# REVISED REMEDIAL ACTION PLAN ADDENDUM - Contingency Plan for Hexavalent Chromium Generation

Former 76 Service Station No. 0843 (2349) 1629 Webster Street Alameda, California

Loc Case No. RO0000450

June 8, 2011

Figure 1 Site Map with Revised Sparge Point Locations and System Locations

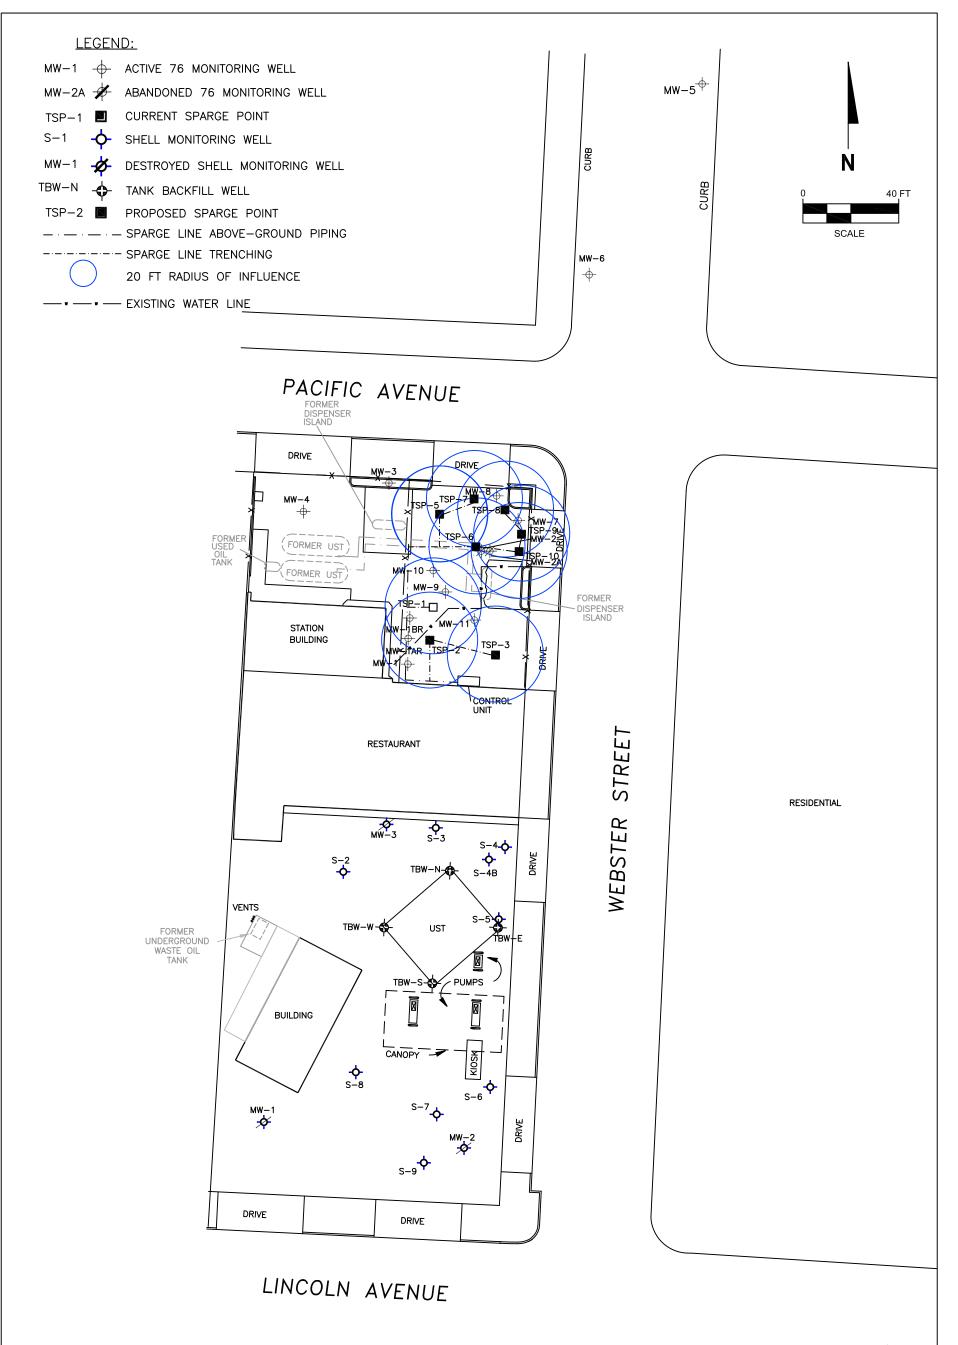
Due to the possibility of increased Cr(VI) concentrations, Antea Group and ConocoPhillips (COP) recommend the sparge point system be started with air/oxygen injection (biosparging) and slowly introduce ozone into the sparge points to minimize the potential for hexavalent chromium [Cr(VI)] generation. No injection will be performed in the vicinity of any wells containing Cr(VI) above the environmental screening level (ESL) of 11  $\mu$ g/L. Currently, as Cr(VI) levels are at 12  $\mu$ g/L in MW-10 as of second quarter 2011 M&S sampling, no injection is intended initially into sparge point TSP-1. Additionally, in order to redistribute the injected ozone, Antea Group recommends the removal of previously proposed sparge well TSP-4, as well as a minor relocation of proposed sparge well TSP-6 slightly south of its originally proposed location. The removal of TSP-4 and the relocation of TSP-6 will allow for more efficient application of air/ozone to the affected subsurface without over-appling to the Cr(VI) affected area in the vicinity of MW-10. A revised site map with proposed locations is included as **Figure 1**.
